# UNITED STATES PATENT AND TRADEMARK OFFICE

10/589,976

Manabu Yagi

<b>Office Action Summary</b>	<b>Application No.</b> 10/589,976	<b>Applicant(s)</b> YAGI ET AL.	
	<b>Examiner</b> PHUTTHIWAT WONGWIAN	<b>Art Unit</b> 3741

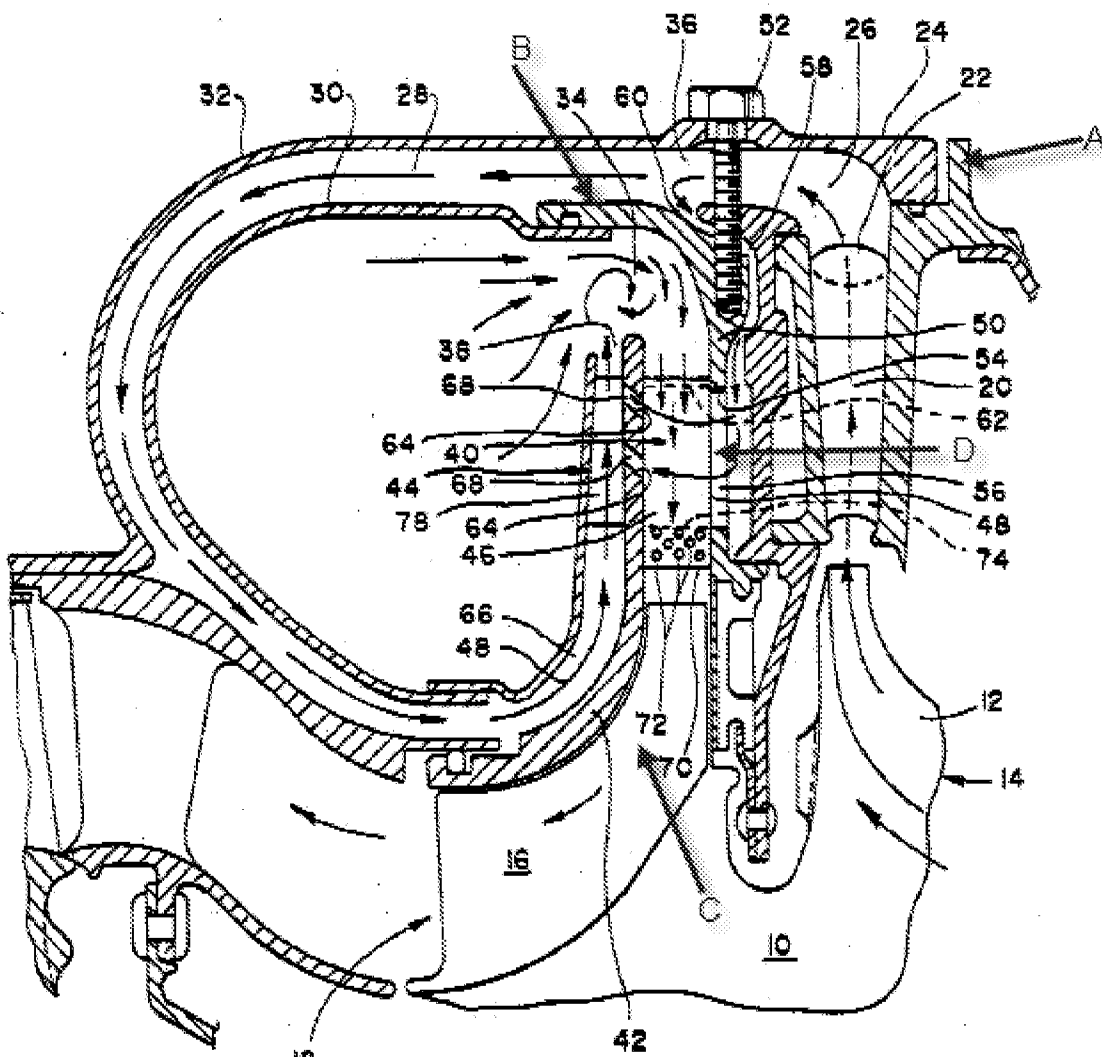
6. Claims 1, 10 and 19 are rejected under 35 U.S.C. 112, first paragraph, as failing to comply with the written description requirement. The claim(s) contains subject matter which was not described in the specification in such a way as to reasonably convey to one skilled in the relevant art that the inventor(s), at the time the application was filed, had possession of the claimed invention. The limitation "a combustor outer cylinder mounted **outside** the outer casing" was not described in the original drawing or specification, the drawing (Fig. 1, A) shows that the combustor outer cylinder 8 is **mounted to the casing 7**, not the outer casing.

16. As to claims 1, 10 and 19-20, Corrado discloses a radial turbine (fig. 1) comprising: an outer casing A (fig. 1, above); a scroll B (fig. 1 above) mounted inside the outer casing which forms a first part 34 (fig. 1) of a combustion gas flow path for guiding a combustion gas generated in a combustor (fig. 1) to a nozzle 40 (fig. 1) which injects the combustion gas to a radial impeller 16 (fig. 1) on an inner side in a radial direction of a rotary shaft (fig. 1); and a shell 42 (fig. 1) which covers the nozzle and the

17. As to claims 2-3 and 11, Corrado discloses that the air flow path is formed to cover an outer side 22, 28 (fig. 1) of the combustion gas flow path communicating from the combustor to the shell, and the through-holes D, 68 (fig. 1 above) is formed in walls of the shell 42 (fig. 1) at a portion upstream of the nozzle.

18. As to claims 5 and 14, Corrado discloses a plurality of the through-holes D, 68 (fig. 1 above) are arranged in parallel along a direction of flow of the combustion gas flow path.

19. As to claims 9 and 18, Corrado discloses a through-hole D, 68 (fig. 1) which leads from one side of the air flow path sandwiching the combustion gas flow path to the other side of the air flow path while penetrating a wall 42 (fig. 1) of the shell, a blade

thick 46 (fig. 1) portion of the nozzle and a wall of the shell on the other side; and a leakage hole 72 (fig. 1) which leads from the blade thick portion of the nozzle of the through-hole to a surface of the nozzle.

20. As to claim 12, Corrado discloses the air flow path 22, 28 (fig. 1) is formed to cover an outer side of the combustion gas flow path communicating from the combustor to the shell 42 (fig. 1), and the through-holes D, 68 (fig. 1 above) are formed in the walls of the shell at a portion upstream of the nozzle.
